SUBJECT: ISSUANCE OF AMENDMENT NO. 70 TO FACILITY OPERATING LICENSE NO.
NPF-10 SAN ONOFRE NUCLEAR GENERATING STATION, UNIT 2 (TAC
NOS. 71174 AND 71175)

SAN ONOFRE NUCLEAR GENERATING STATION, UNIT NO. 2

Amendment No. 70
License No. NPF-10

ATTACHMENT TO LICENSE AMENDMENT NO. 70

Figure 3.4-2

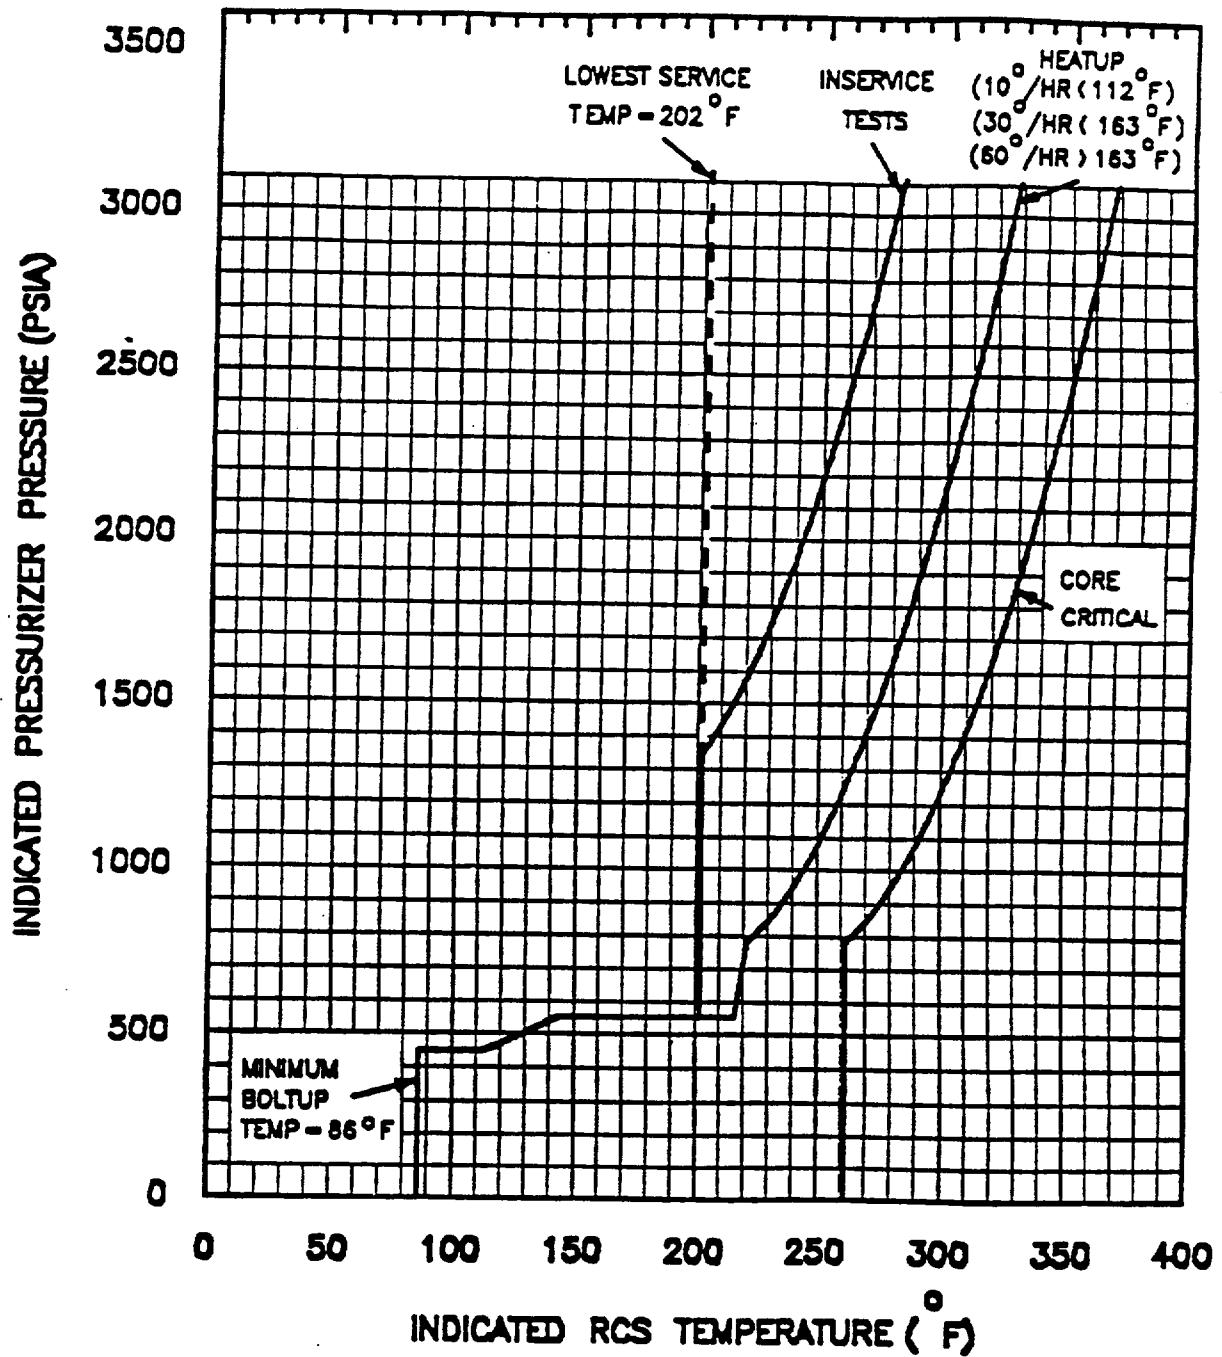
3.4.8.1 The Reactor Coolant System (except the pressurizer) temperature and pressure shall be limited in accordance with the limit lines shown on Figure 3.4-2 and Figure 3.4-3 during heatup, cooldown, criticality, boltup, and inservice leak and hydrostatic testing with:

- a. A maximum heatup of 10°F in any one hour period with RC cold leg temperature less than 112°F. A maximum heatup of 30°F in any one hour period with RC cold leg temperature less than 163°F. A maximum heatup of 60°F in any one hour period with RC cold leg temperature greater than 163°F.
- b. A maximum cooldown of 10°F in any one hour period with RC cold leg temperatures less than 103°F. A maximum cooldown of 30°F in any one hour period with RC cold leg temperatures less than 145°F. A maximum cooldown of 100°F in any one hour period with RC temperature greater than 145°F.
- c. A maximum temperature change of less than or equal to 10°F in any one hour period during inservice hydrostatic and leak testing operations above the heatup and cooldown limit curves.
- d. A minimum temperature of 86°F to tension reactor vessel head bolts.
